Design Review Board

Wednesday, May 27, 2020

5:40 – 7:00	5) Centennial Trail – Summit Blvd: Recommendation Meeting	Dean Gunderson
	• Declaration of possible Ex Parte Communication	
	• Staff Report..... 5-10 m	
	• Applicant Presentation..... 10-15 m	
	• Board Discussion and Motion(s)..... 45 m

Driveway Turning Movement - Backing out of Driveway w/ 19ft long vehicle

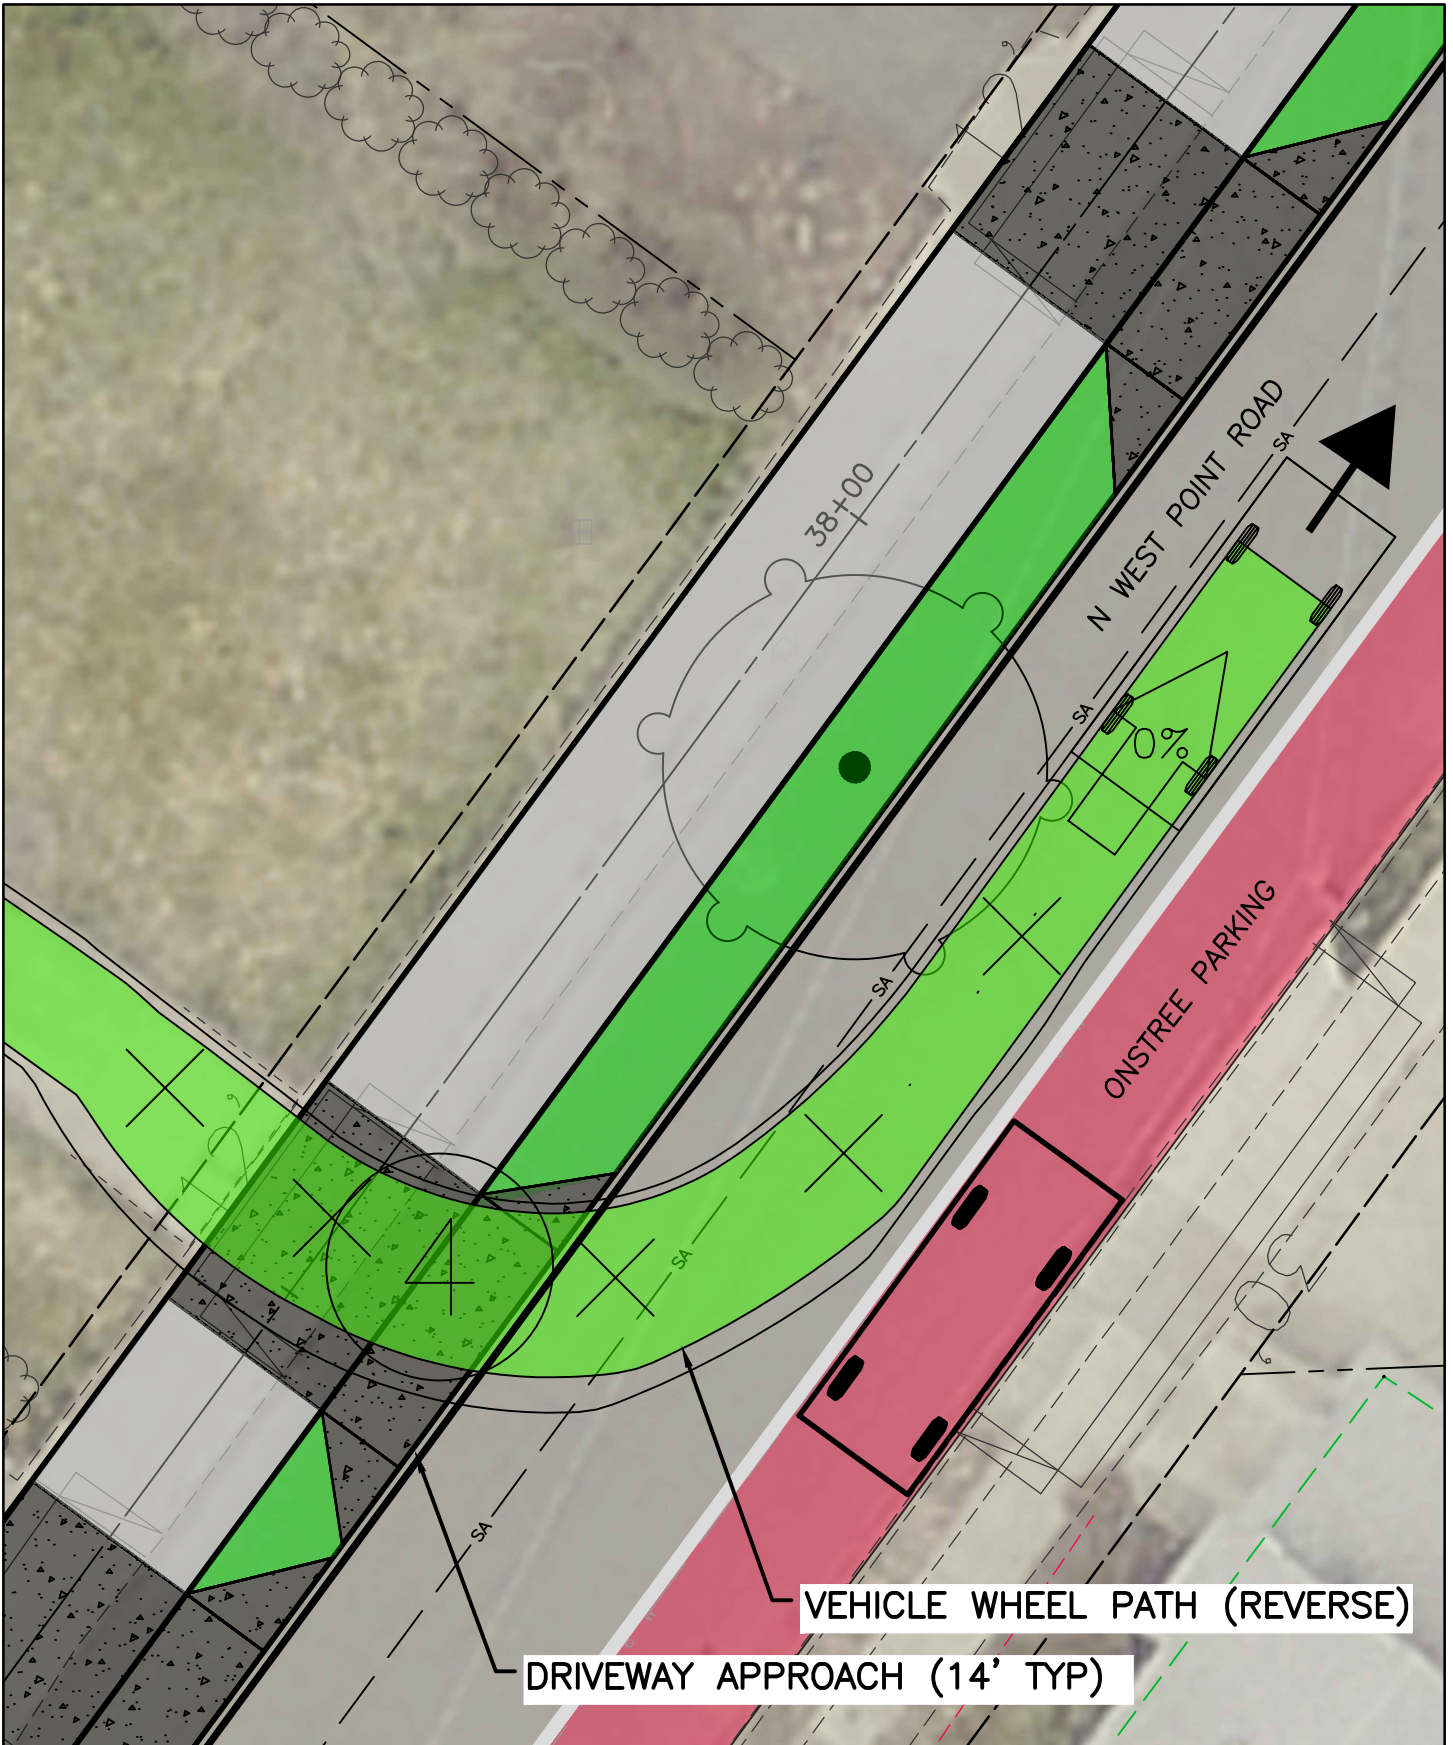
5. The board recommends the applicant further explore the geometry and function of the design as presented in Road Section Detail B, with particular focus on the ability of a resident to successfully operate a vehicle while pulling in and backing out of their driveway while crossing the proposed Centennial Trail pathway, passing between the landscape buffer, and navigating the possibility of a vehicle being parked across the street in the parallel parking area.

- *From the response to recommendation #1 above, note that there all but five driveways on Mission Ave./West Point have the ability to turn around on the driveways such that they would not back out of their driveway. And on West Point, to which this recommendation pertains, only two homes lack the ability to turn around and would therefore be backing out of their driveway.*
- *For those two driveways (and all the others on West Point), we propose a widened approach flair (equivalent to what is provided on an arterial) to facilitate the backing out movement.*
